Proposed Change 1950

Code Reference(s):	NBC20 Div.B 9.7.6.1. (first printing) NBC20 Div.B 9.27.2. (first printing) NBC20 Div.B 9.27.3. (first printing)
Subject:	Building Envelope - General
Title:	Protection from Precipitation of the Rough Opening Sills for Windows and Doors
Description:	This proposed change clarifies the requirements for protection from precipitation of rough opening sills for windows and doors to more closely align these requirements with established building science principles and standards.

Figure [A-9.27.2.-A]**Rough opening - Second plane of protection maintained into the rough opening**

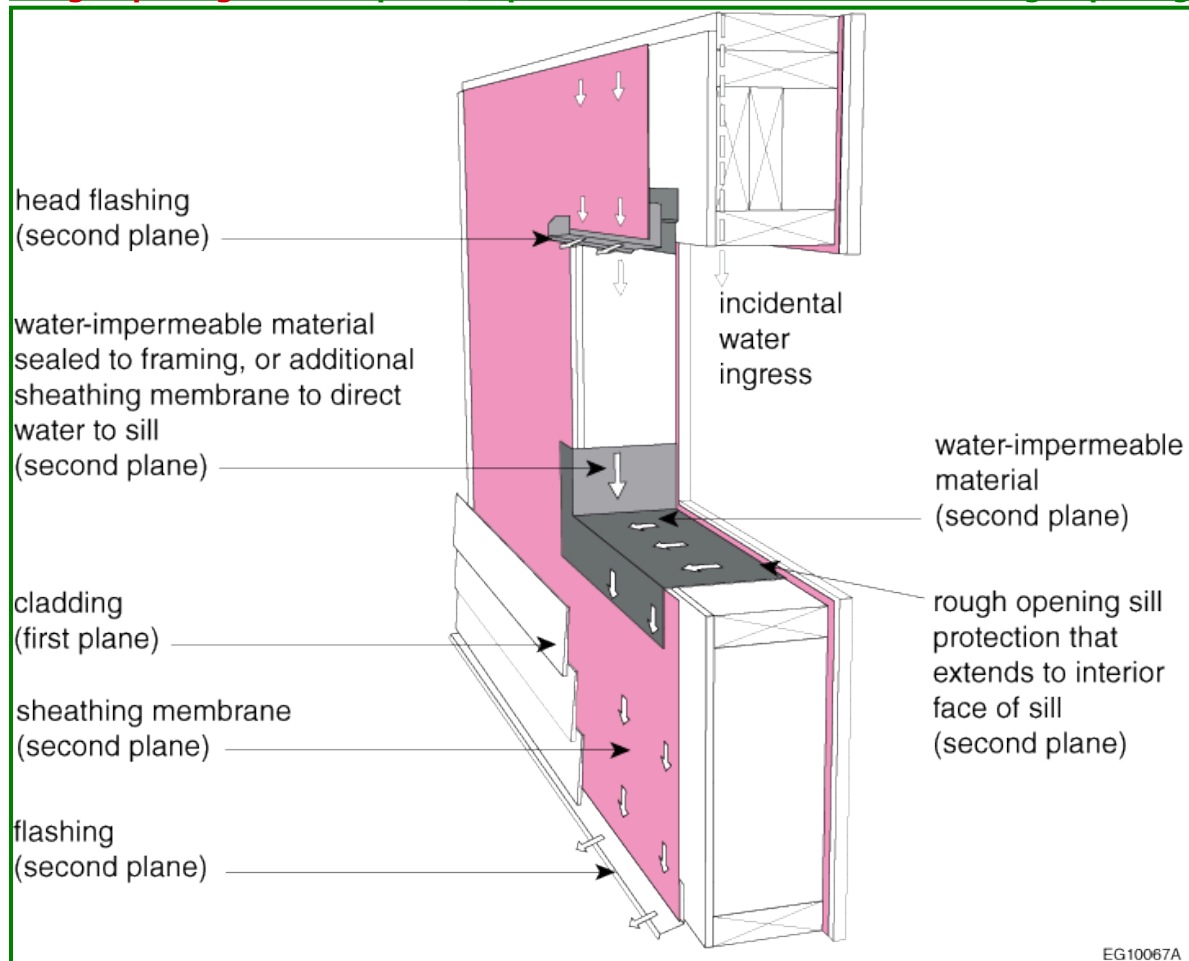
For windows or doors, the rough opening that penetrates the cladding system plays a crucial role as part of the concealed barrier assembly or second plane of protection. Incidental water may penetrate the first plane of protection or may enter from areas above or around a window or door (e.g., as the result of a failed window or door unit). Extending the second plane of protection into the rough opening at the sill, as shown in Figure 9.27.2.-A, ensures that this incidental water is collected and diverted back to the exterior over the protected sill. Thus, the rough opening, as a distinct feature, contributes to the effective management of water ingress and enhances overall performance. These characteristics are particularly important as insulation and airtightness levels increase at higher energy performance tiers, since higher levels reduce drying potential in the event of unintended water ingress.
